MEMORANDUM

INTERMOUNTAIN POWER SERVICE CORPORATION

TO: Joe Hamblin  
FROM: Dennis Killian   
DATE: July 13, 1989  
SUBJECT: Boiler Inspections, November, 1989, Outage  
FILE: 01.12.02 & 43.5800

UNIT 1 BOILER INSPECTION  
SCHEDULED OUTAGE-----NOVEMBER 1989

# Unit 2 Reheater Outlet Access.

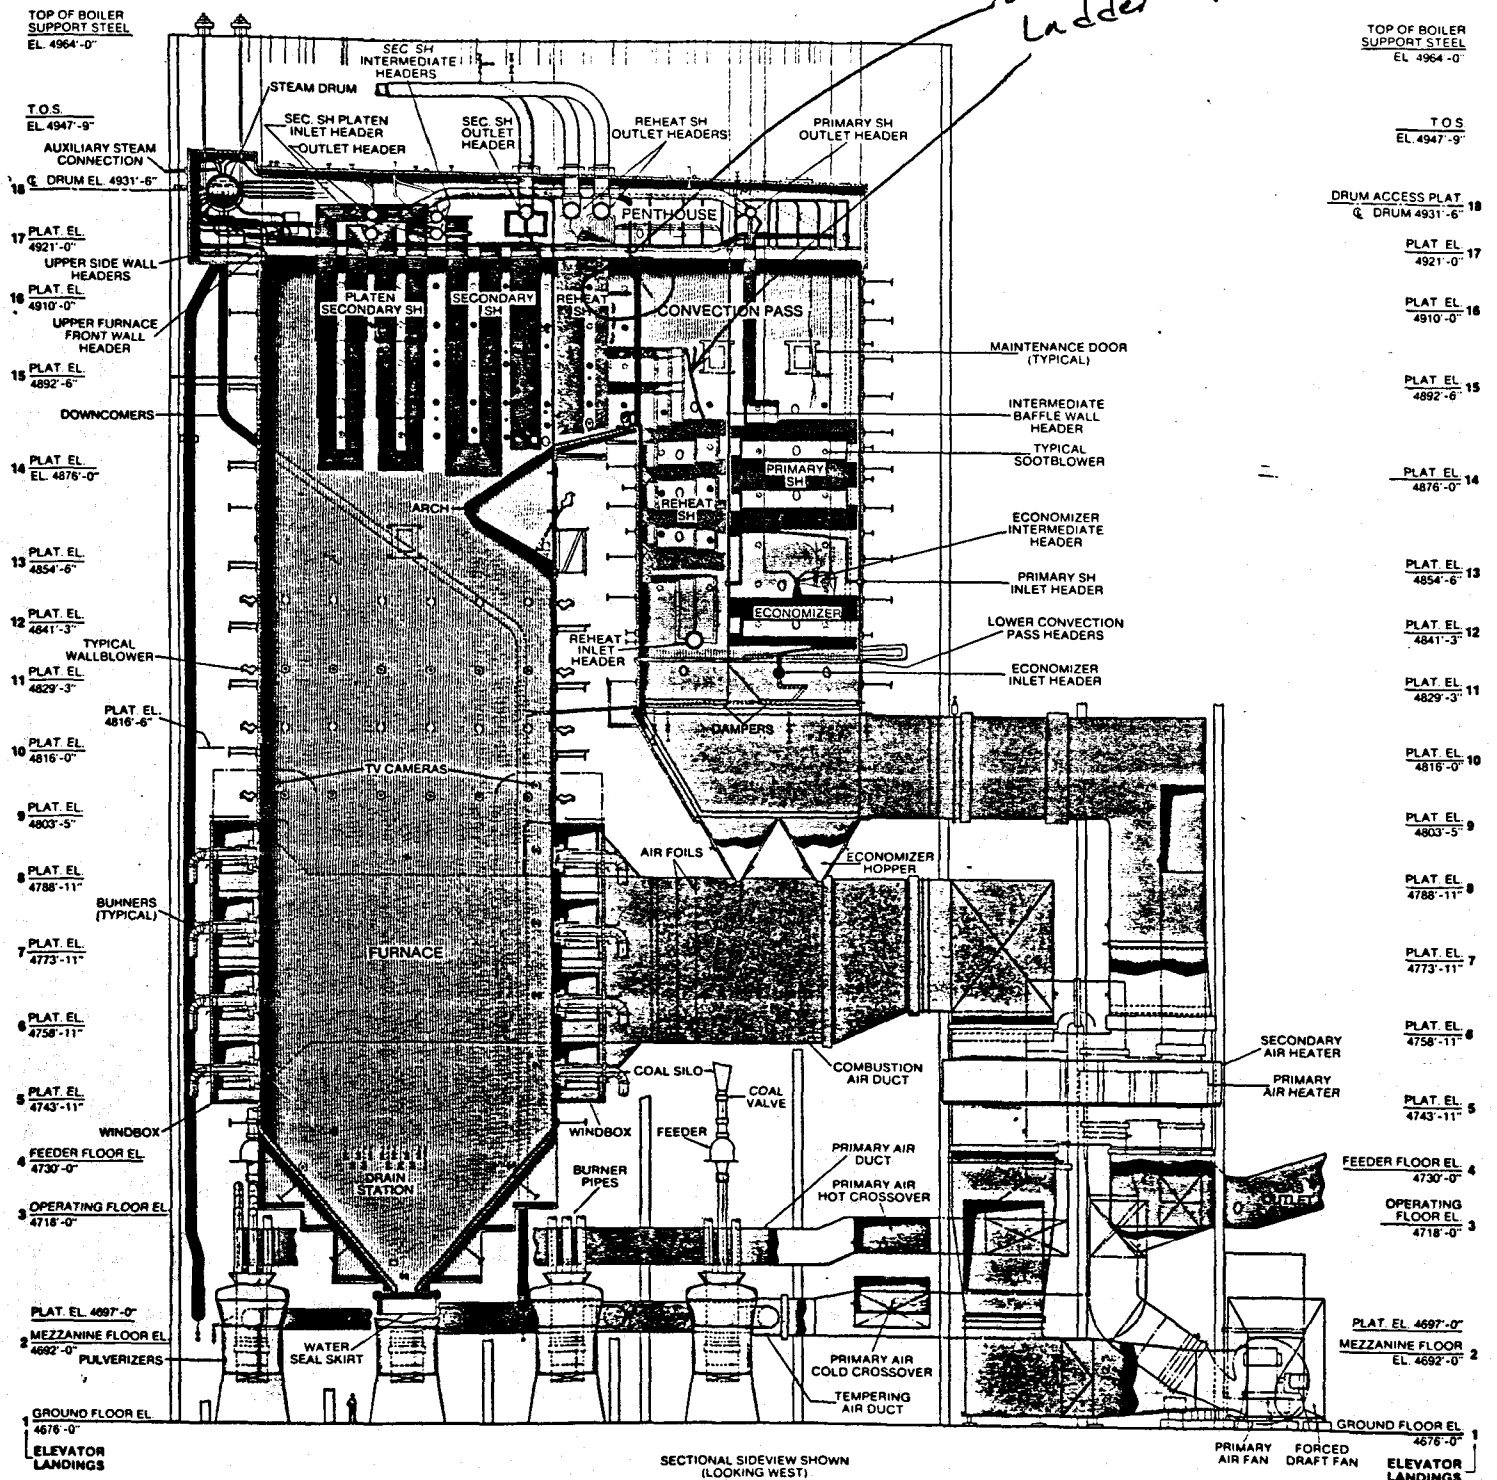
The support clips located 3' below the roof tubes were previously repaired by B&W. The original shop welds were removed, and the existing clips were rewelded using multiple stringers. Visually inspect all of the panels at the clip elevation. Install a ladder from the 14 to 15 elevation up the rear side of the reheater. Lay plank across the reheater elements from east to west. Place another ladder up the rear side of the reheater to reach the clips. The ladder will have to be moved approximately 30 times for inspection. Inspect each panel for evidence of leakage and select two tubes along the clips to remove for testing. Notify Stan Smith to examine the tube internals for surface condition. Test the sample tubes at a laboratory for defects in accordance with B&W ARC report dated May 19, 1989 (see attachment).

access.  
ladder + walkway?
